IMPORTANT RECALL INFORMATION #70802

**SUBJECT: RECALL CAMPAIGN #70802
2008 DISCOVERY, EXCURSION, PROVIDENCE 39R MODEL -
UNSECURED PROPANE GAS HOSE**

Recall Bulletin 70802

SUBJECT:
Secure the
Propane Hose
Under the Galley
Slide-Out

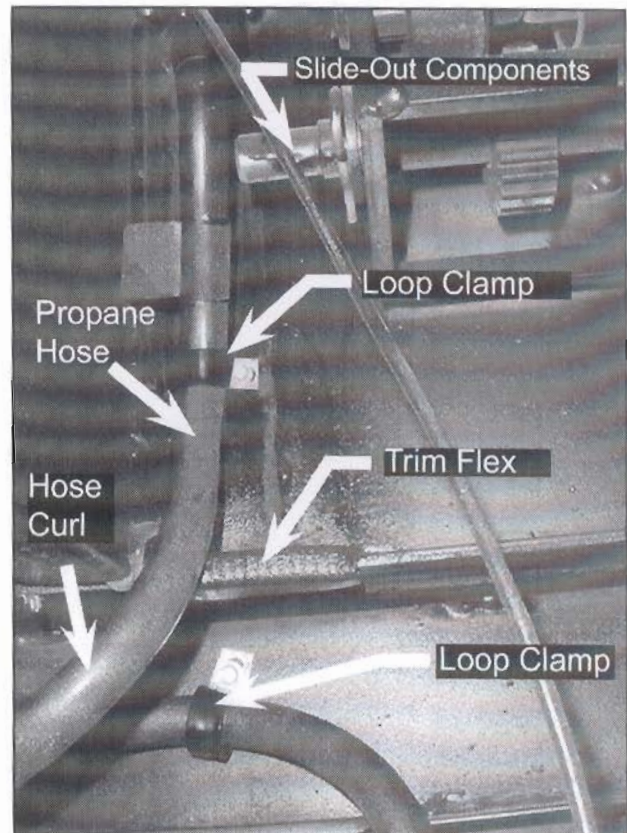
The propane hose, under the galley slide-out room, can flex and make contact with other components during slide-out room operation. This may lead to abrasion or kinking of the propane hose.

9. Install one insulated loop clamp, as shown in the photo, to secure the top portion of the propane hose away from the slide-out system drive shaft and extension arm assembly.
10. Install a second insulated loop clamp, as shown in the photo, to secure the curled lower portion of the propane hose.
11. Attach a length of Trim Flex to the steel edge of the Power Platform "I" beam flange for additional protection. See photo.
12. Verify the propane hose has clearance from all pinch points, abrasion areas, and sharp metal edges.
13. Turn on the Battery Disconnect Switches.
14. Turn on the Ignition switch and close the galley slide-out room.
15. Retract the levelers.
16. Start the engine to inflate the air suspension.
